La Crosse Boiling Water Reactor  
Facility Operating License No. DPR-45  
NRC Docket Nos. 50-409 and 72-046

Subject: Response to October 14, 2022 Request for Additional Information for Class 1  
Excavation and Basement Survey Units

**La Crosse Boiling Water Reactor (LACBWR) - Request for Confirmatory Information  
Related to the Remaining LACBWR Class 1 Survey Units**

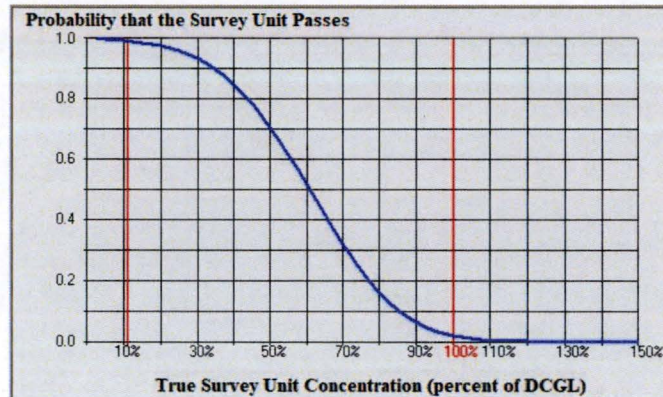
**RCI:** Please confirm that the statistical test for L1-SUB-CDR and the number of systematic samples required for the statistical test are still valid given that several of the samples were invalidated due to them being in L1-SUB-TDS A and L1-SUB-TDS B after the original survey unit was divided.

*LaCrosseSolutions* confirms that the samples taken during the FSS of the CDR are still valid. An analysis was performed to test the validity of the data if the samples in the area were removed from the overall data set. The number of samples from CDR that could have been impacted is five. These samples are 8, 10, 11, 13, and 14. When removed from the data set, the remaining results pass the Sign test as detailed below:

A retrospective calculation was then performed to determine the number of samples needed using Equation 5-2 of MARSSIM:

The result of the calculation is 8.61, resulting in nine samples. LACBWR typically used 0.05 as the value of  $Z_{1-\beta}$  but is allowed to increase the value in accordance with Section 5.6.4.1.1 of the LTP. The value was not increased by 20% since the calculation was performed retrospectively.

A retrospective power curve was then created using the data set using an alpha value of 0.05, beta value of 0.10, sigma of 0.1347 and a LBGR of 0.11. The power curve is displayed below:

This confirms that the number of systematic samples required for the statistical test is valid even if the samples are removed from the CDR data set.
